Your Ref: PL2025/06615
Our Ref: CP0110

**RE: PL2025/06615 (4 FLEXIBLE B8 STORAGE/ OR CLASS E COMMERCIAL BUSINESS AT UPPER SEAGRY HOUSE)
LETTER OF REPRESENTATION
(OBJECTION)**

Arboricultural Technical Note

Transport Technical Note

Figure 1. Plan 250603-SH-COM-TTP Base-NB shows encroachment of the RPA of T14 by 15.7%.

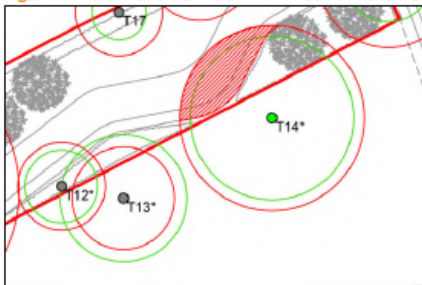
commercial and storage businesses. Works would therefore be necessary within their RPZs and would impact their ability to thrive. Whilst the use of a cellweb type construction may marginally reduce the impact on the routes of T13 and T14, the RPZ remains breached and impacted. It therefore remains a negative in the planning balance which is further impacted by the very substantial loss of trees and habitat on site (referred to in point 4 above). The attached arboricultural assessment (**APPENDIX 1**) illustrates the impact on my client's TPO tree. It also highlights that the application access plans and the impact on TPO trees are inconsistent (see figures 1-3 later in this letter).

Figure 1. Plan 250603-SH-COM-TPP Base-NB shows encroachment of the RPA of T14 by 15.7%.

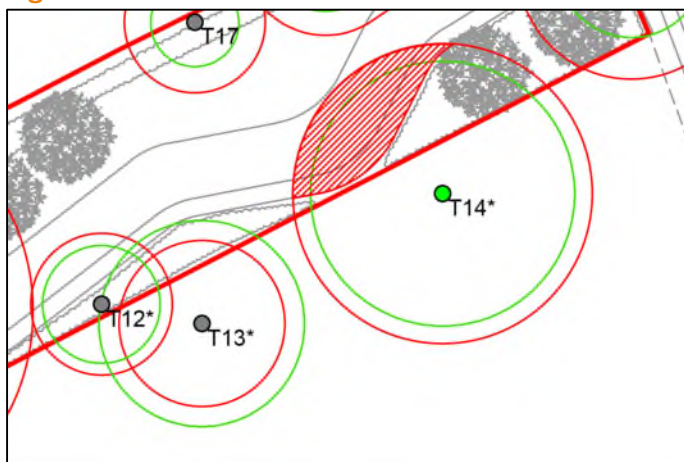
The proposed access road will encroach into the Root Protection Area (RPA) of T14 and potentially T13. However, there is considerable discrepancy between the plans as to the level of encroachment and proposed mitigation.

Two separate Tree Protection Plans have been submitted (ref. 250603-SH-COM-TPP Base-NB and 250626-SH-COM-TPP-NB), and the road alignment differs in both. Both plans differ from the road

Tree T14 is a mature tree and encroachment into the RPA is likely to have deleterious impact. Although the discrepancies in the plans make an accurate assessment difficult, the level of encroachment shown is would not be acceptable for the long-term health of the tree and does not comply with BS5827:2012. The submitted Arboricultural Method Statement (AMS) does not propose any mitigation for works within the RPA of T14 and is therefore not acceptable.

Figure 3. Preliminary Access Layout 23075 PHL-01 C shows encroachment of the RPA of T14 by 8%.

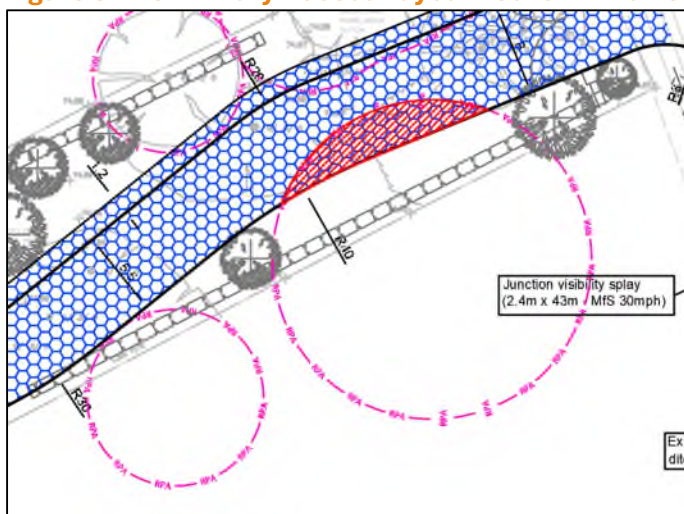
alignment shown in the Transport Statement (Preliminary Access Layout 23075 PHL-01 C), as shown in the **Figures** below.

Figure 2.1: Extract of drawing 23075-PHL-01C

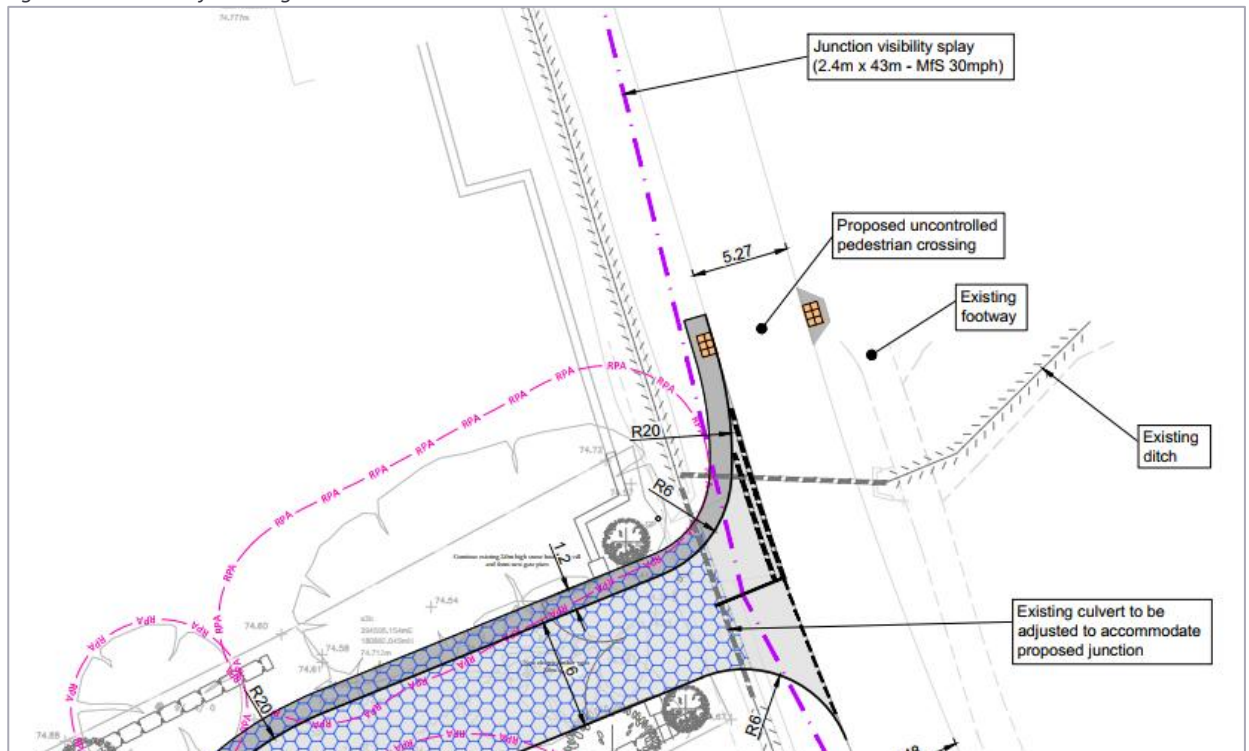
- 2.1.7 Whilst the visibility splays are shown for drivers exiting the access, the TS fails to consider the visibility splay requirements for pedestrians at the proposed dropped-kerb tactile paving crossing points. At these points, visibility splays of 1.5m x 43m are required, in accordance with the requirements of the

DfT document *Inclusive Mobility (December 2021)* and *CD 143 Visibility at junctions and crossings*. Furthermore, in accordance with MfS, the visibility splays should be free of obstacles above a height of 600mm.

Figure 2.2: Culvert post and rail fence - view taken 1.5m back at location of proposed crossing point

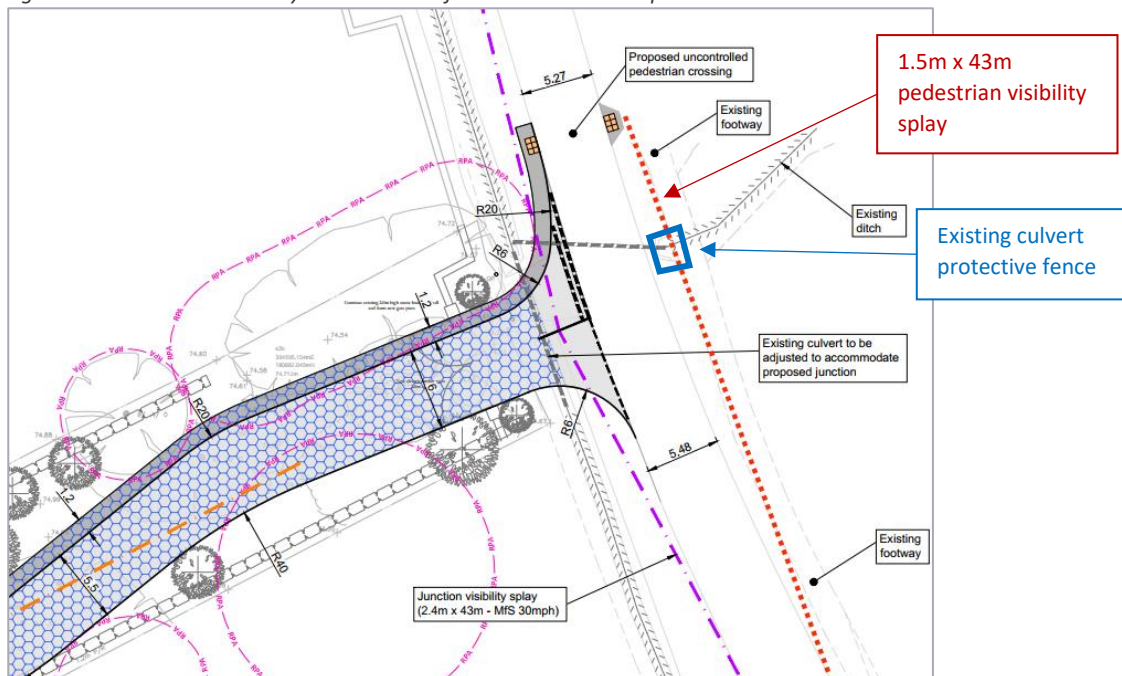
- 2.1.8 Opposite the proposed access junction and approximately 10m south of the eastern tactile paving is an open culvert which is protected by a timber post and rail fence. This presents a significant obstacle within the required visibility splay and exceeds the maximum height of 600mm.
- 2.1.9 Figure 2.2 presents the view looking south from the eastern crossing point, 1.5m from the kerb edge, and Figure 2.3 illustrates the height of the obstacle.

Figure 2.3: Height of post and rail fence - 920mm minimum

Figure 3.1: Extract from tree protection plan (source: Hillside Trees Ltd)

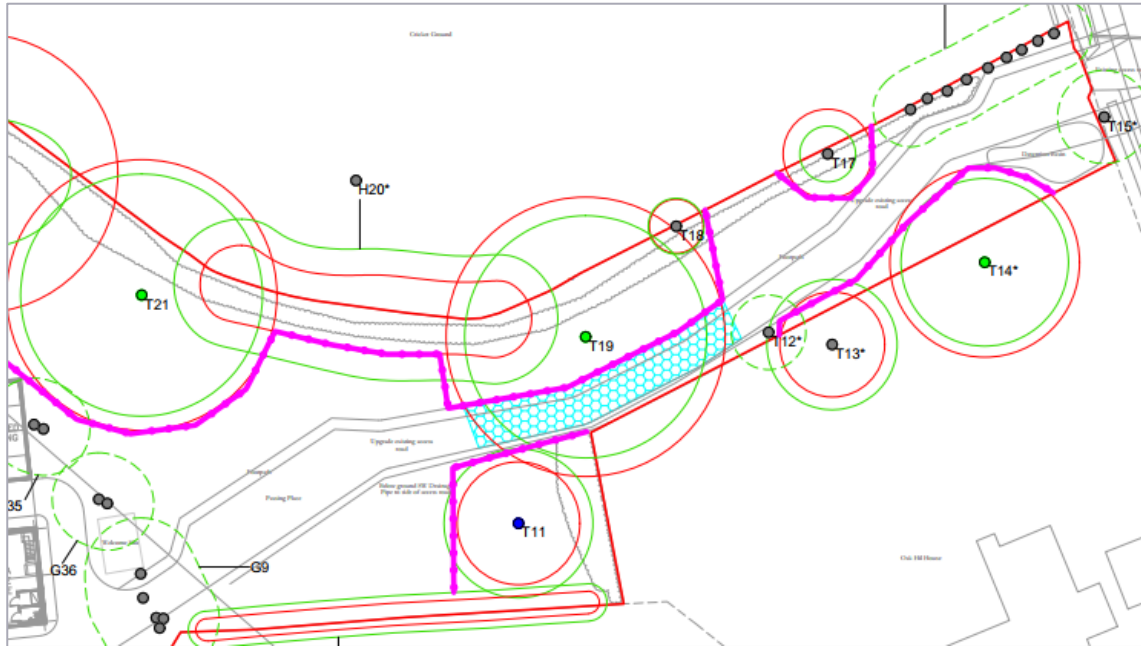
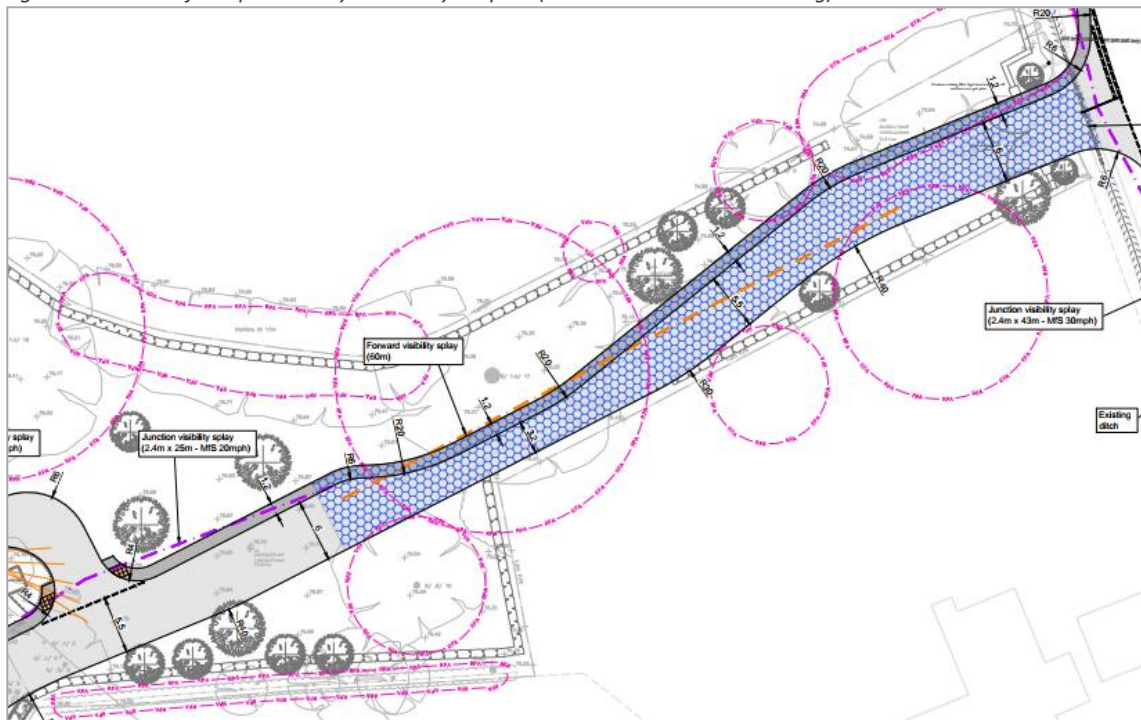
- 3.1.1 There is a discrepancy in the submitted information regarding the access road layout, with different layouts shown in the TS and that included within the Arboricultural Report on the tree protection plan prepared by Hillside Trees Ltd (plan reference: 250626-SH-Comm-TPP-NB). Both layouts are shown in Figure 3.1 Figure 3.2 respectively.

- 3.1.2 Presumably the proposed access road layout is the one included in the TS and as shown at Figure 3.2 – this should be clarified. Moreover, it is unclear whether this layout has been assessed by the Arboriculture consultant in respect of impacts upon the root protection area.

- 3.1.3 Moreover, GE Consulting has undertaken a review of the arboriculture report on behalf of our client, Mr Andrew Scott, and this has found significant concerns with the impacts of the access strategy upon the root protection area. Given these concerns, it is unclear whether the access road layout as shown in the TS will be deliverable in practice. It is therefore necessary that the arboriculture impacts are confirmed in order to assess whether the access strategy is suitable or not.
